**Air Pollution Control
Title V Permit to Operate
Draft Permit No. V-UO-000004-00.00
Draft Initial Part 71 Permit**

**Deseret Power Electric Cooperative
Bonanza Power Plant
Uintah and Ouray Reservation
Uintah County, Utah**

Statement of Basis

Figure 1.⁴²

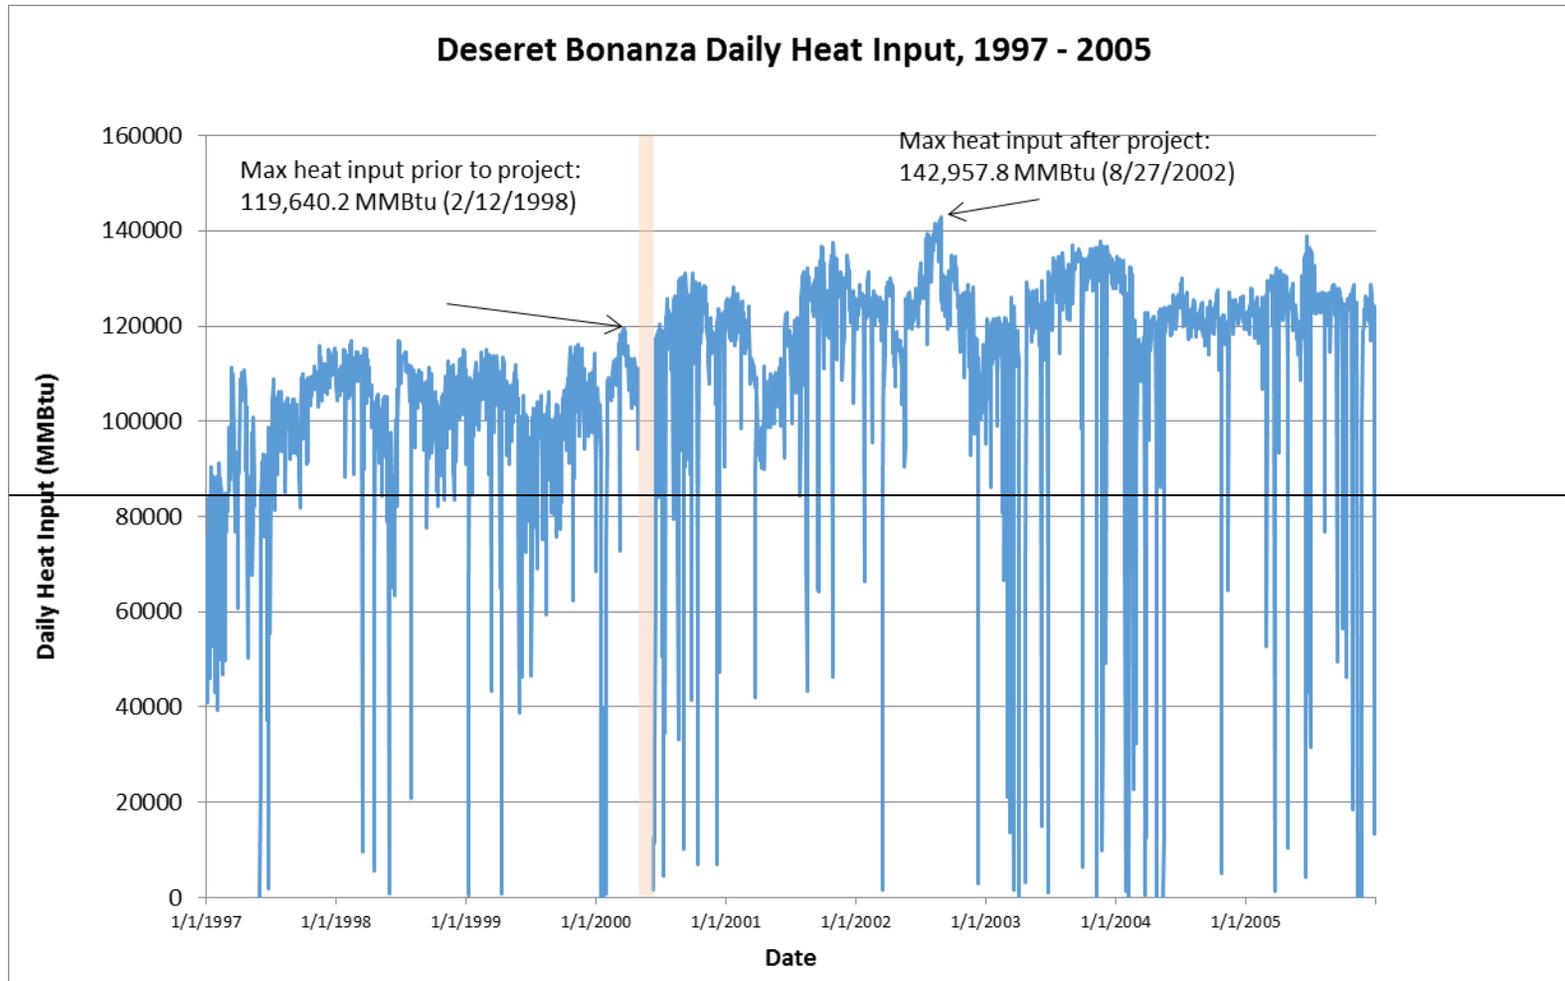
During the public comment period for the initial draft Title V permit in 2002, the NPS commented that a ruggedized rotor installation that Deseret constructed in 2000 may have increased actual emissions by “significant” amounts as defined in the regulations, thereby triggering the PSD major source modification permitting requirements in 40 C.F.R. § 52.21, explaining that:

EPA has examined daily actual heat input data on the Bonanza power plant from 1997 through 2005, in an attempt to evaluate the extent to which an increase in actual heat input capacity may have occurred and been utilized as a result of the ruggedized rotor project.³² Results are presented in Figure 1, at page 52 below. For example, if one compares the pre-project daily actual heat input values with post-project daily actual heat input values, then it appears that actual post-project heat input has, in fact, been in excess of the plant's pre-project capacity.³³ Prior to the project, the maximum actual daily heat input was 116,940 MMBtu, while after the project the maximum actual daily heat input was 142,958 MMBtu. Moreover, following the project, the actual daily heat input exceeded the pre-project maximum of 116,940 MMBtu on most days. When considered

Thus, EPA has preliminarily determined that the Federal PSD permit issued in 2001 failed to apply the PSD regulations correctly because EPA relied on a faulty analysis conducted by the State and did not conduct a complete, independent analysis of whether the ruggedized rotor project was subject to PSD review based on the regulations in place at that time and whether a revision of the emission limits in the 1981 Federal PSD permit for the Bonanza plant was appropriate. We now recognize our error and, as noted previously in this document, EPA will undertake a separate error correction PSD permitting action in the near future that will undergo its own public notice and comment period. However, as part of the current Title V permitting action, EPA is proposing terms and conditions in the draft Title V permit requiring Deseret to request an administrative permit amendment to revise the Part 71 permit to incorporate the terms of the final and effective Federal PSD permit correction for this facility, shortly after the PSD permit correction process is completed. *See* Draft Permit, Section III.D. “Compliance Schedule and Progress [40 CFR 71.6(c)(3) and (4); 71.5(c)(8)(iii)].”

significant net increase in actual NO_x emissions; and therefore, EPA has made a preliminary determination that the 2001 PSD permit action should have included PSD major modification review for Deseret's ruggedized rotor project.
